REVISED FINAL QUALITY PROGRAM PLAN NAS FORT WORTH TX
3/1/1999
FANNING, PHILLIPS AND MOLNAR

**RISK-BASED ASSESSMENT, MANAGEMENT, AND CLOSURE
OF SOLID WASTE MANAGEMENT UNITS AND AREAS OF CONCERN
AT NAVAL AIR STATION FORT WORTH, JOINT RESERVE BASE,
CARSWELL AIR FORCE BASE, TEXAS**

**REVISED FINAL
QUALITY PROGRAM PLAN**

Contractor Response to Comments for Final Work Plan for Carswell AFB, DO 23

FIGURE 4-1. Organizational Chart

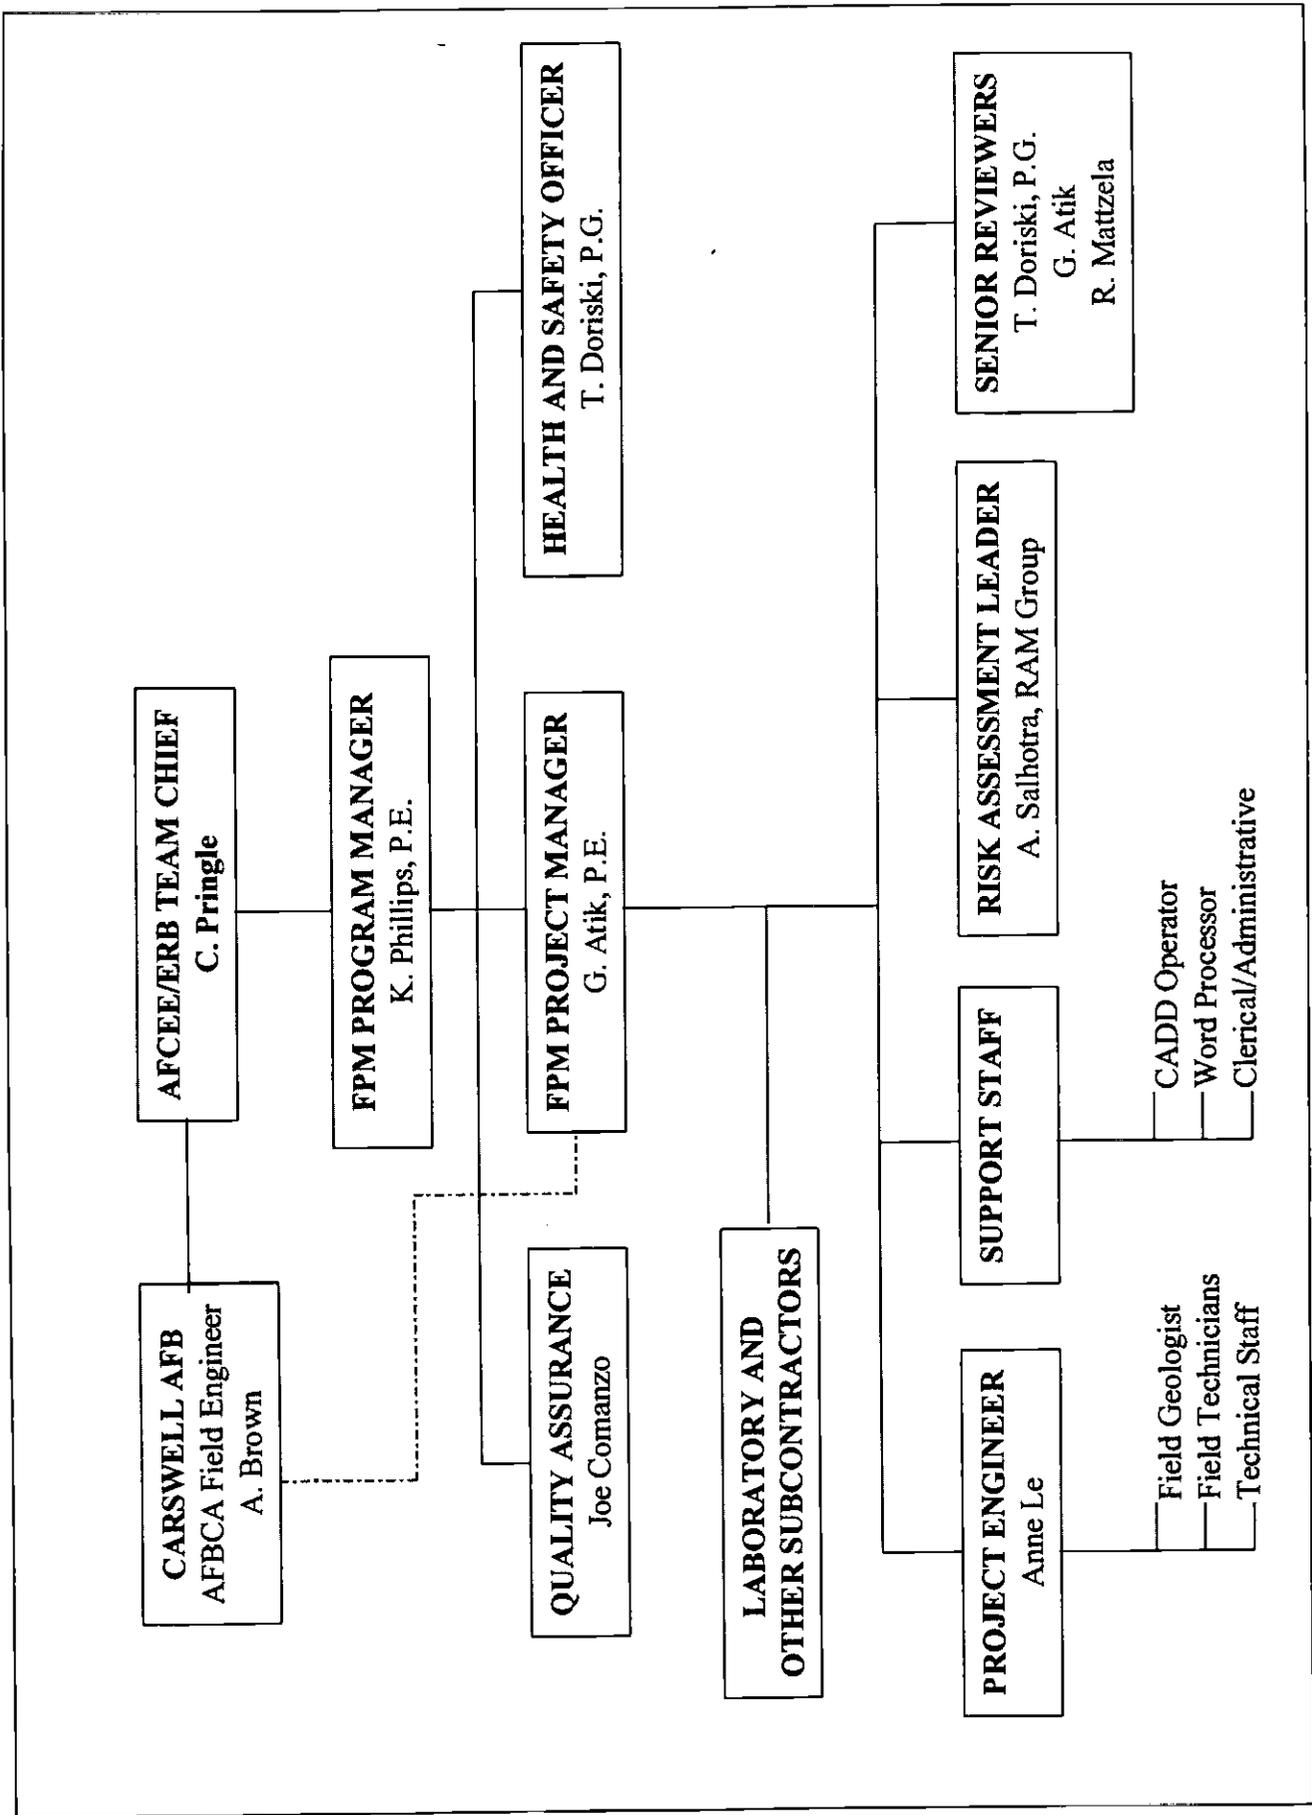
10.	4-2	Figure 4-1	Mr. Charles Rice is listed as the AFCEE/ERB Team chief. This needs to be changed to Mr. Charles Pringle.	Revised.
